URBAN DESIGN COMMITTEE

URBAN DESIGN COMMITTEE STAFF REPORT

APPLICATION NUMBER	Urban Design Record #23126
APPLICATION TYPE	Advisory Review
ADDRESS/LOCATION	205 S 10 Street
HEARING DATE	December 05, 2023
ADDITIONAL MEETINGS	-
APPLICANT	Joy Skidmore, joy@theannexgrp.com
STAFF CONTACT	Arvind Gopalakrishnan, 402-441-6361, agopalakrishnan@lincoln.ne.gov

UDR23126 - Central at D Haymarket (205 S 10th St)

Material Palette

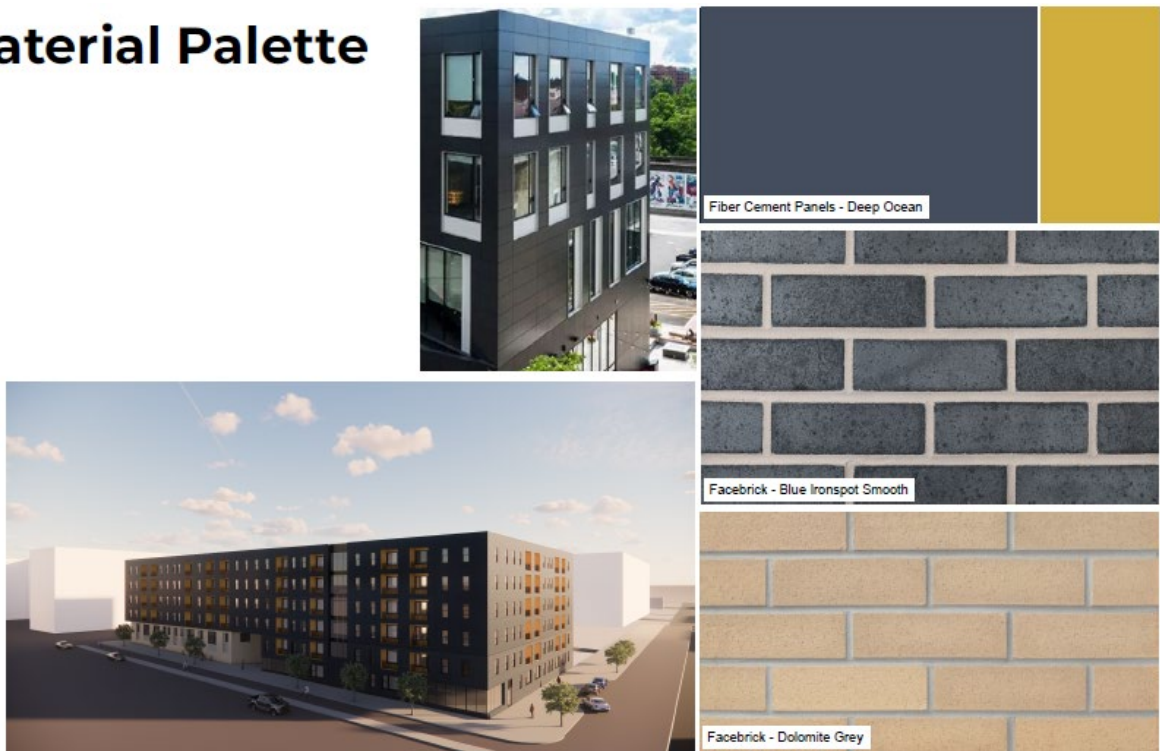
The proposal displays the use of facebricks up to the third story from the sidewalk, fiber cement panels from the third story up to the top of the building.

City staff supports the material choice and the color palette, and suggests that the North elevation fronting N Street have a pop of color or other feature (i.e. yellow fiber cement panel in the floors above the main entrance shown below). This would not only help emphasize the entrance to the building, but also create a

Streetscape Design:

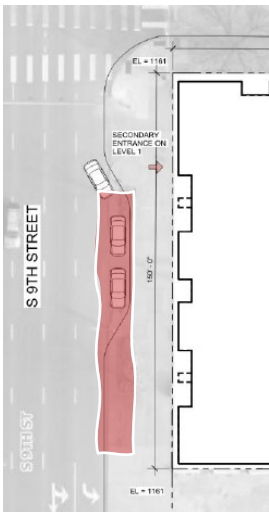
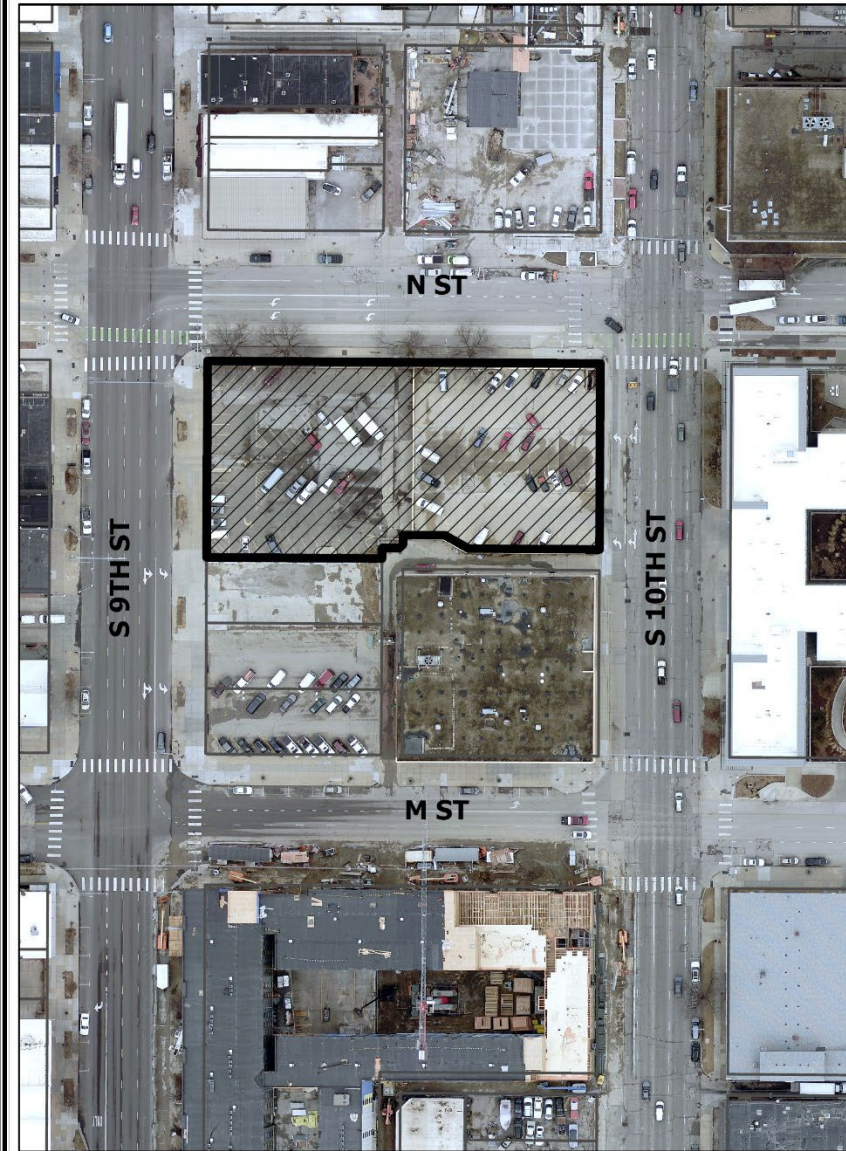
In the updated drawings, the proposal shows a preliminary vehicular drop-off area near the secondary entrance on level 1, on 9th Street. Staff recommends that the proposed area drop off area on 9th Street be extended southwards to the extent of the building and provide more space for loading and unloading. This detail will need to be addressed at a later date, along with streetscape design concepts.

Landscaping and other streetscape design concepts will be presented at a later date, likely in early 2024. This will be a coordinated effort between the applicants and the concerned departments of the City to ensure that the proposed design aligns seamlessly with the City’s overarching goals for 9th and 10th Streets as part of the Downtown Corridors Project, emphasizing safe and efficient traffic movement for pedestrians, cyclists and vehicles, while creating a visually appealing urban environment.

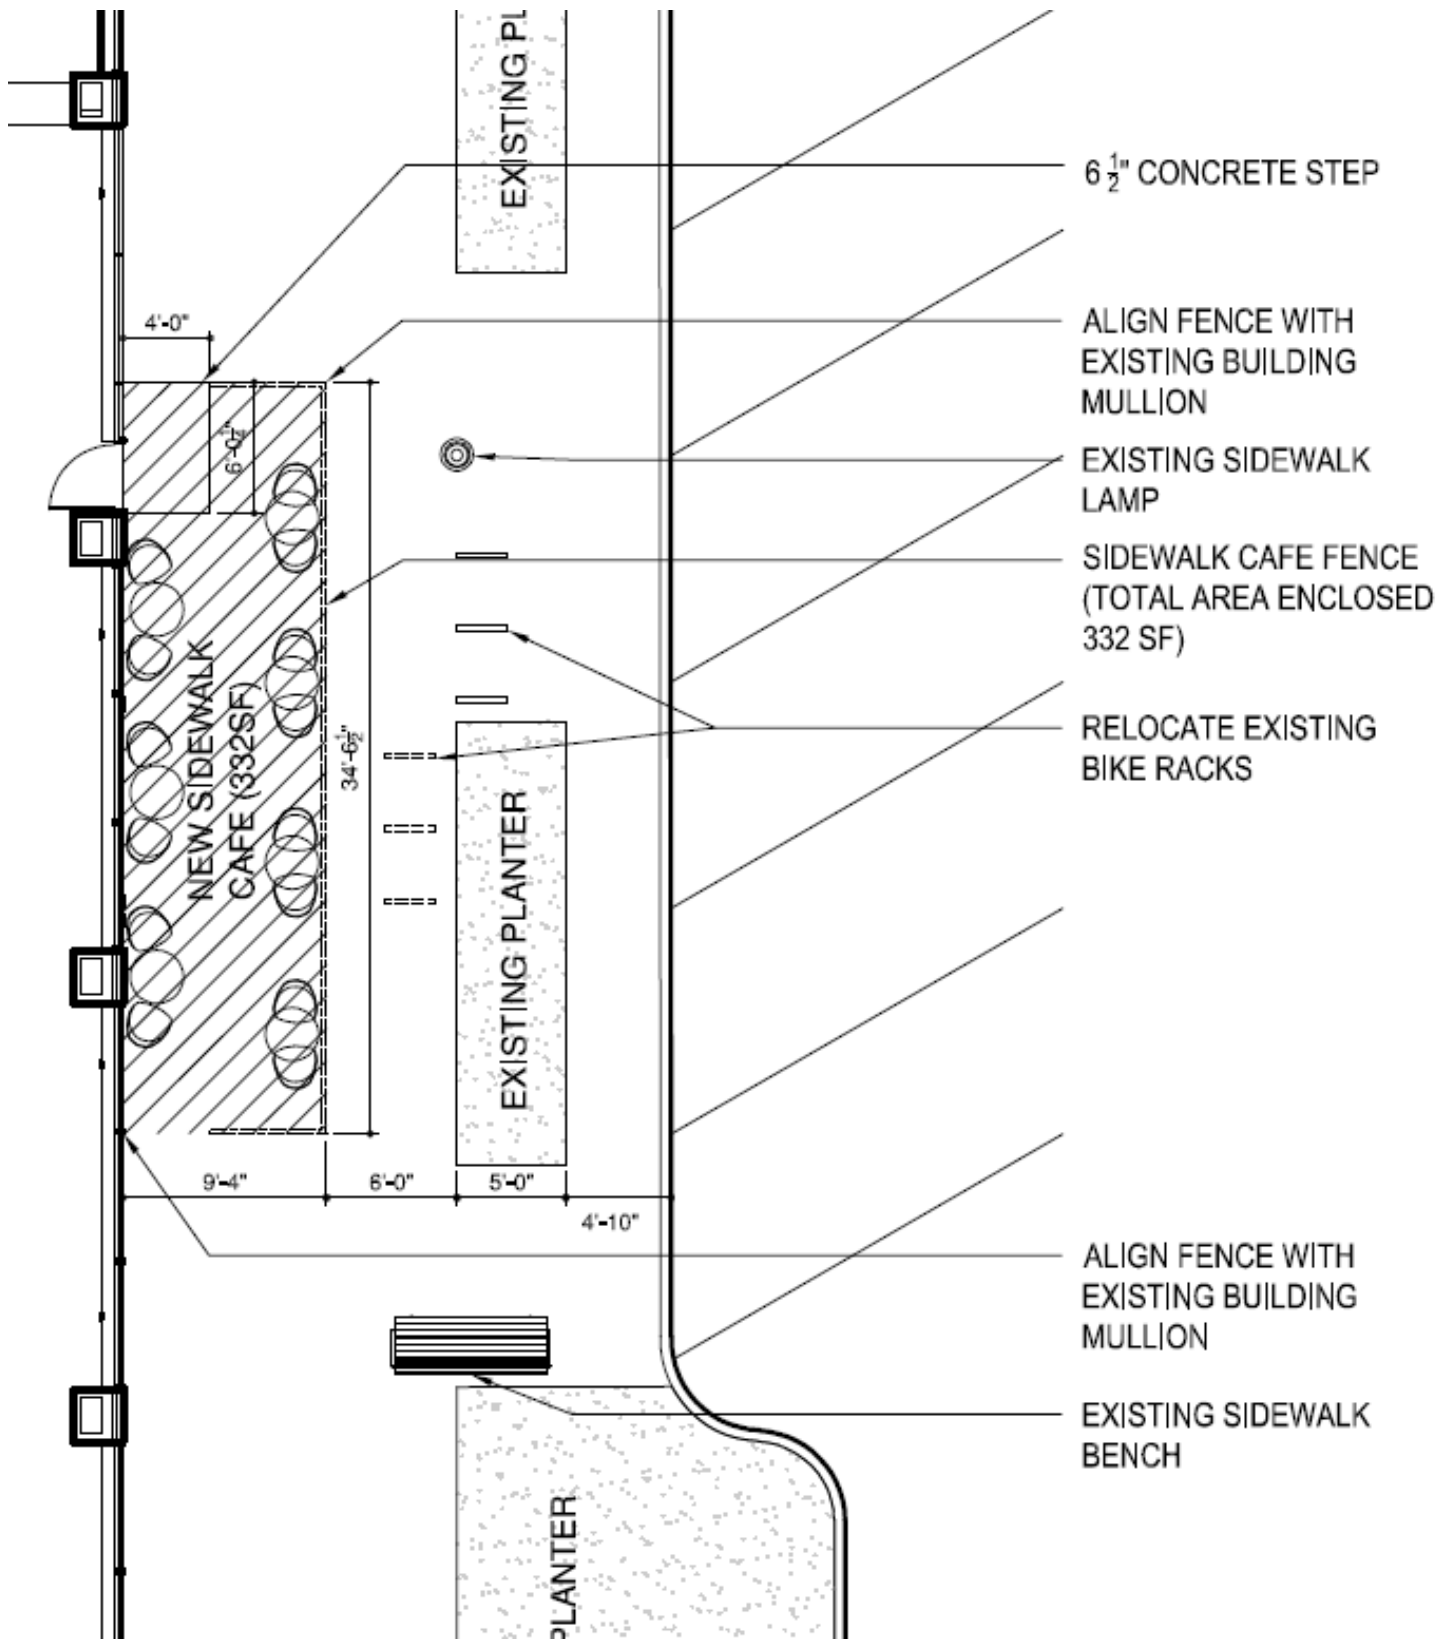
The fencing has been installed as per the drawings, and the bike racks have been uninstalled to make space for pedestrians. After the removal of the bike racks, the current sidewalk café width of 9’-4” would leave 6’ for pedestrian movement. The city will coordinate with the DLA to install the bike racks slightly east, aligned with the existing planter.

City staff also recommends that the metal bench just south of the café and the set of 2 benches north of the café (circled in the map above), be removed from its current position, and relocated about 3' to the east, aligned with the existing planters. This would help ensure a smooth flow of visitors to and from the sidewalk café and leave enough space for bike parking without interrupting the pedestrian flow on the sidewalk.

The sidewalk space available for movement abutting the building is approximately 15'-6" wide. Installing a 9'-4" wide fencing would leave around 6' of passageway for pedestrian movement spanning the length of the building fronting N 11th Street.

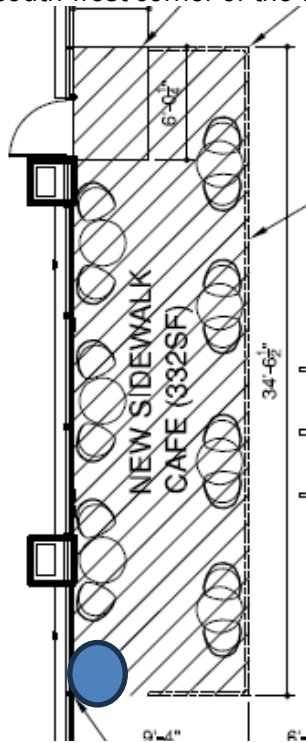
The DLA has removed the 3 bikeracks and will be in touch with the city for relocation, to make sure that it doesn't encroach on the pedestrian passageway.

The city will also coordinate with the DLA to remove metal bench south of the café, and find an appropriate spot for relocation. Since this part of 11th Street falls in the Downtown Corridors Project

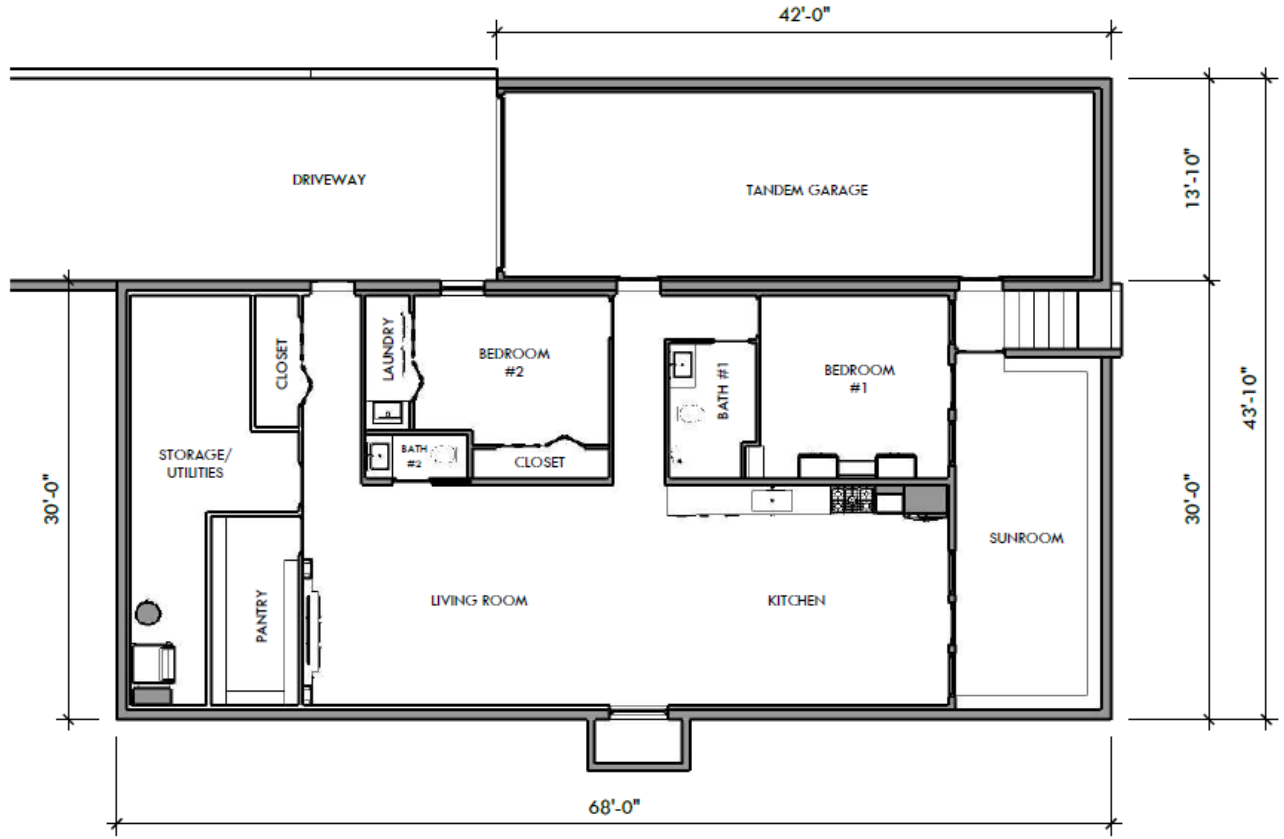
Given the nature of the project, the Planning Department recommends the garage have a white laminate or a frosted glass door instead of a fully opaque door. Although it would still not meet the window and opening requirements, at least some design intent or feature to accentuate the façade is advised.

Since this house design does not blend with the neighboring properties, we also recommend incorporating colorful and ornamental plants and shrubs around the garage for to improve the overall appearance of the property and foster a more cohesive architectural context within the community.
